City of Detroit
Inter-Departmental Communication

RE: Petition No. 441
Request for Various Outright Vacations In The Area Bound By Winfield, St. Cyril,
Georgia, And Huber

NOTICE OF PROPOSED CHANGE IN PROPERTY

REQUEST OUTRIGHT VACATION
 IN THE AREA BOUND BY
 WINFIELD, ST. CYRIL, GEORGIA
 AND HUBER

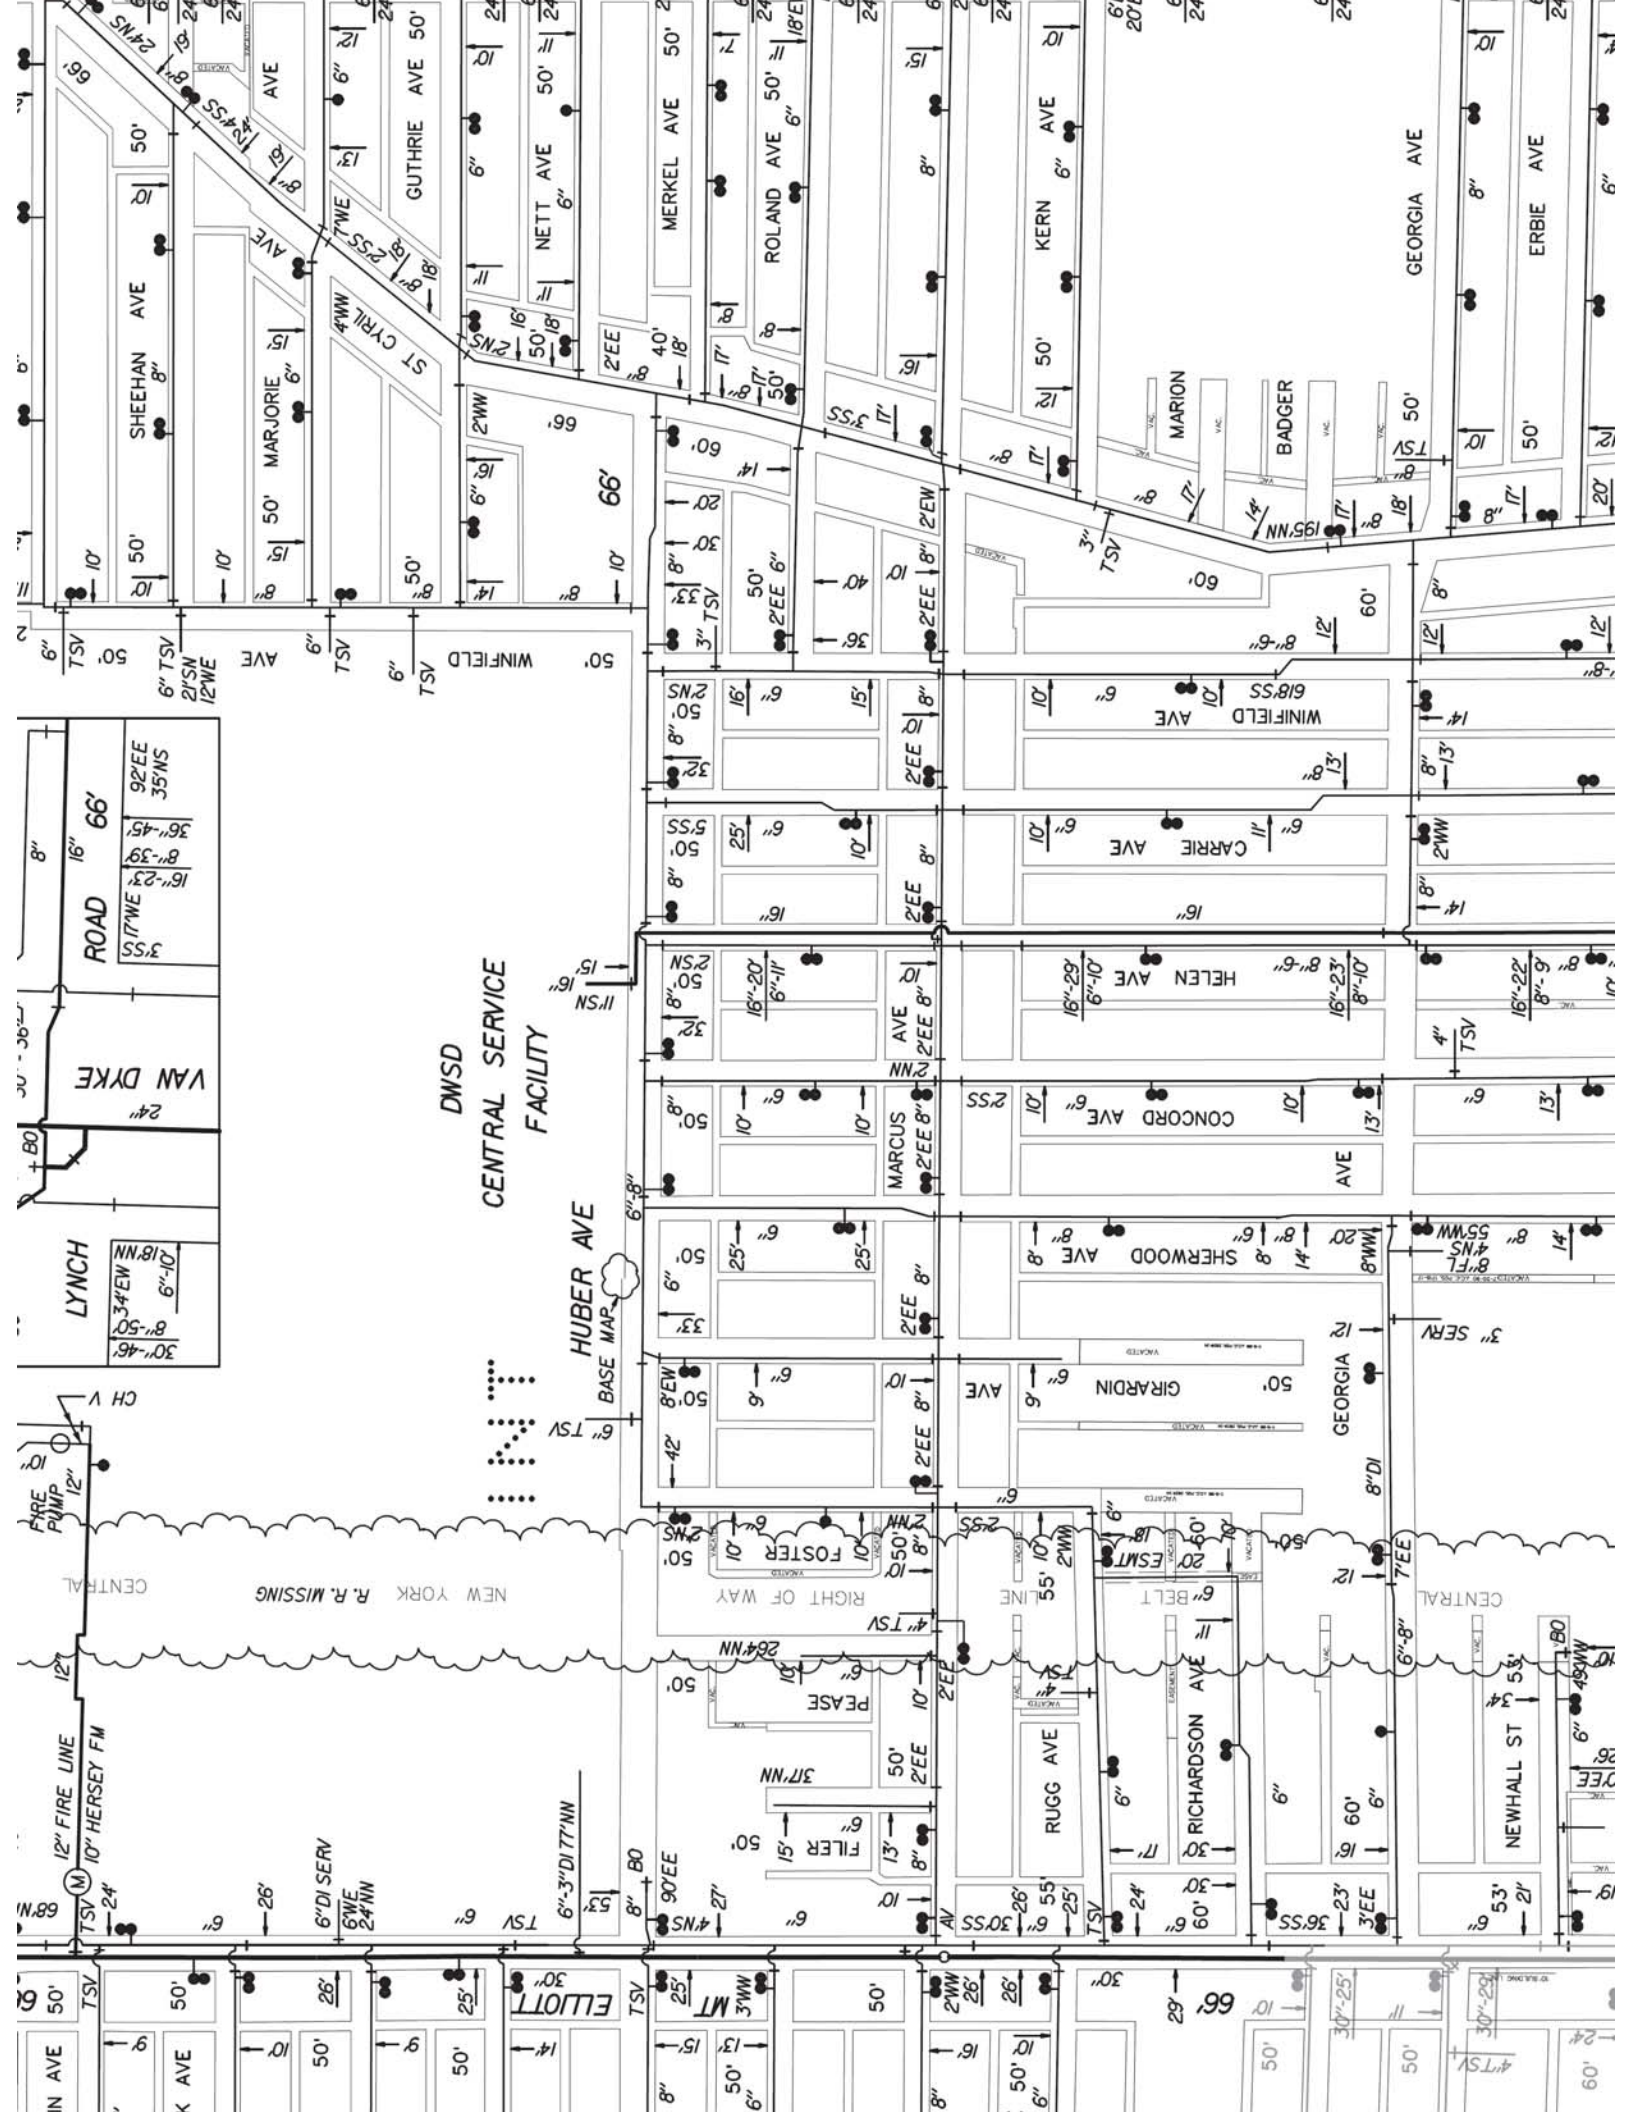
- Our records indicate that there are water mains and sewers in requested areas of vacation. DWSD objects to the vacations. However, DWSD has no objections if the petitioner agrees to relocate the water mains and sewers in accordance to the attached provision for relocation at no cost to DWSD.

Provided that the petitioner shall design and construct proposed sewers and water mains and to make the connections to the existing public sewers and water mains as required by the Detroit Water and Sewerage Department (DWSD) prior to construction of the proposed sewers and water mains,

Provided that the plans for the sewers and water mains shall be prepared by a registered engineer; and further

Provided that DWSD be and is hereby authorized to review the drawings for the proposed sewers and water mains and to issue permits for the construction of the sewers, and further

Provided that the entire work is to be performed in accordance with plans and specifications approved by DWSD and constructed under the inspection and approval of DWSD; and further

Provided that the entire cost of the proposed sewers and water mains construction, including inspection, survey and engineering shall be borne by the petitioner; and further

Provided that the petitioner shall grant to the City a satisfactory easement for the sewers; and water mains and further

Provided, that the petitioner shall provide DWSD with as -built drawings on the proposed sewers and water mains; and further

Provided that the petitioner shall provide a one (1) year warranty for the proposed sewers and water main; and further

Provided that upon satisfactory completion, the sewers and water mains shall become City property and become part of the City system. And any existing sewers and water mains that were abandoned shall belong to the petitioner and will no longer be the responsibility of the City.
